Access Compliance Report Public Rights-of-Way (Pedestrian Signals)

Intersection ID: N/A **Main Street:** Cross Street: N/A Location: N/A

Signal Type: One Push Button-Non APS Severity Score: BTN 1:N/A BTN 2: N/A No BTN: N/A ADA ID: A18FDB3D672B **Overall Compliance: No**

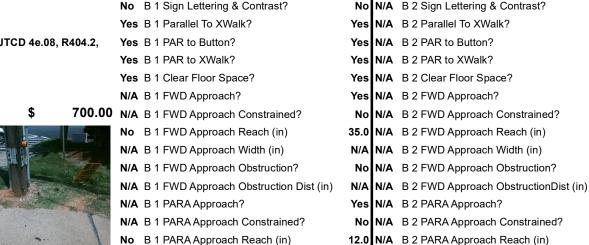
PROW/ADA: R410.6. TMUTCD 4e.08. R404.2. R404.3, R406.2, R404.7.3

Possible Solutions: Replace Signal Push Button With APS Button on New Post. Remove & Replace Sign.
